## Product Change Notification

**1. ECR #:** 164364  
**Notification #:** 333

**3. Series:**  
• SSM - .025 SOCKET STRIPS

**4. Part #'s Affected**  
• SSM-1XX-XXX-DV-XX-XX-XXX-XX

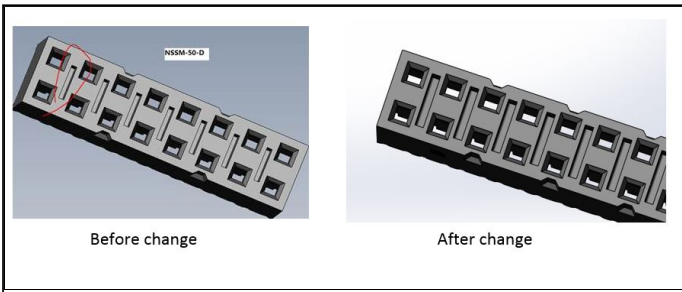
**5. Description of Change:**  
Void Coring features were updated to the top side of the body for improved flatness.

The change in void coring can be visually identified, without magnification, by viewing the top side of the part.

Void coring was modified in order to improve the flatness of the body during the molding process.
